**RE:** ITB No. 20-119, MT-01 Asford Dunwoody / Peachtree Road Intersection Improvements.

**ADDENDUM 2**

**ITB 20-119**

**MT-01 ASHFORD DUNWOODY / PEACHTREE ROAD INTERSECTION IMPROVEMENTS**

CHECKED:	DATE:	DRAWING No.
BACKCHECKED:	DATE:	27-0002
CORRECTED:	DATE:	
VERIFIED:	DATE:

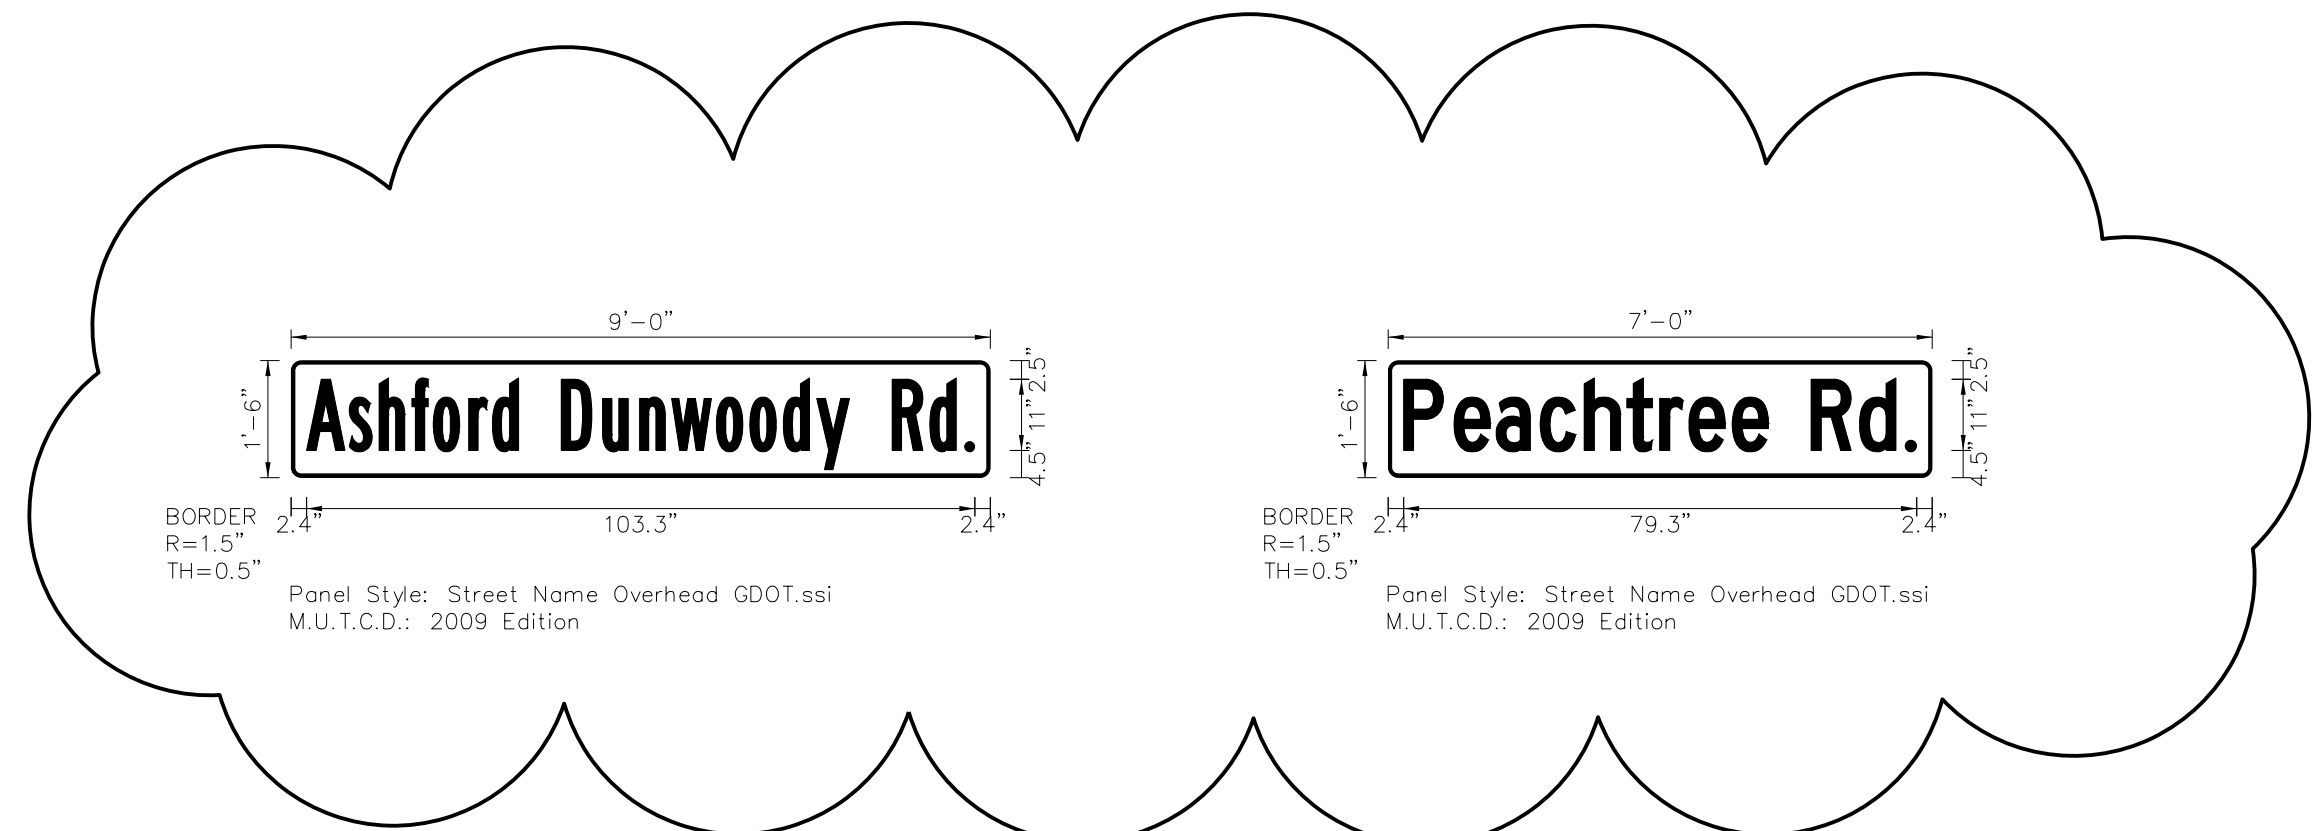
6. The signal items in the bid schedule are different than the pay items on signal plan sheet 27-0002. Which items should we bid?

8. The traffic signal plans show directional boring pay items and TP 3, 2 IN conduit but those pay items were not included in the proposal. There are pay items for TP 2, 4 IN & TP 2, 6 IN conduit but none of that conduit is called for on the signal drawings.

**Signal quantities on 27-002 and bid form have been updated. (See attached)**

**Signal quantities have been updated. (See attached sheets)**

CHECKED:	DATE:	DRAWING No. <b>44-0001</b>
BACKCHECKED:	DATE:	
CORRECTED:	DATE:	
VERIFIED:	DATE:

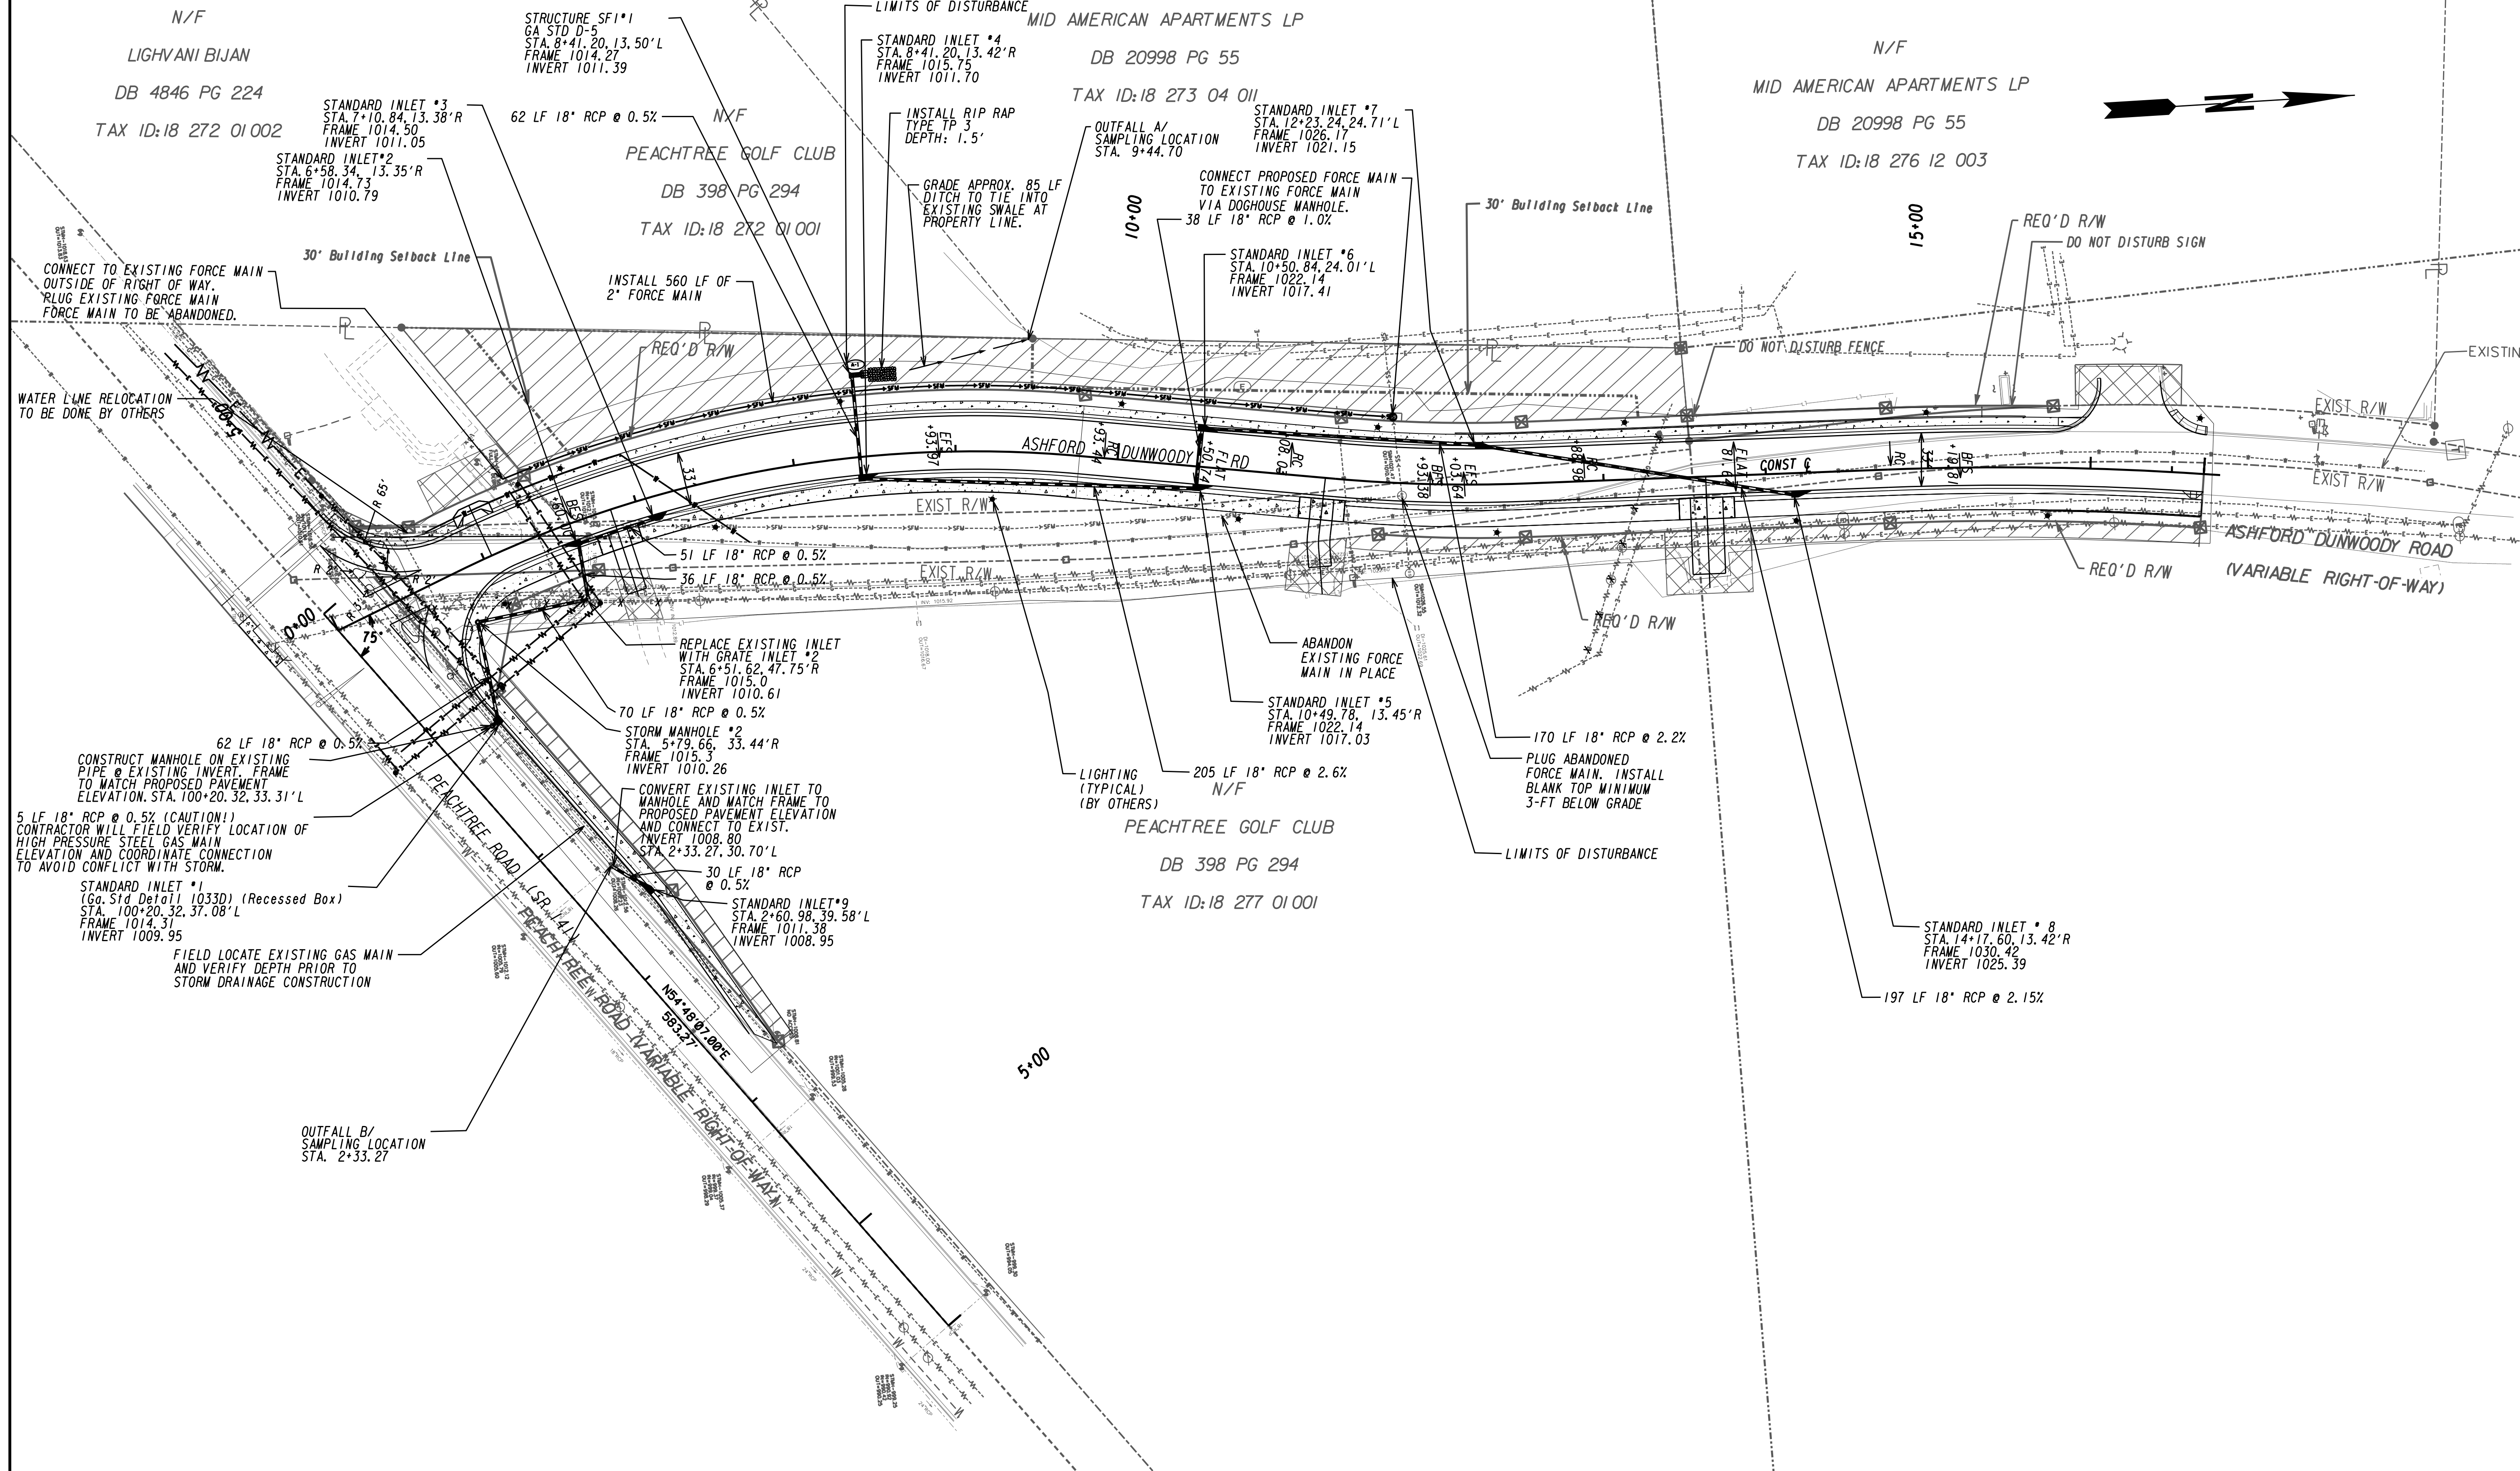
4. Drawing No.22-0002 (Drainage Profile) shows gas and water lines conflict with the proposed drainage pipes. Please clarify who is responsible for the following:

- b) **Relocation of the water mains**  
**The contractor will need to coordinate with DeKalb County for on the relocation of the water main as shown on Drawing No. 44-0001.**

- CONTRACTOR SHALL COORDINATE WITH DEKALB COUNTY FOR THE RELOCATION OF THE WATER MAIN AS SHOWN ON DRAWING NO. 44-0001.
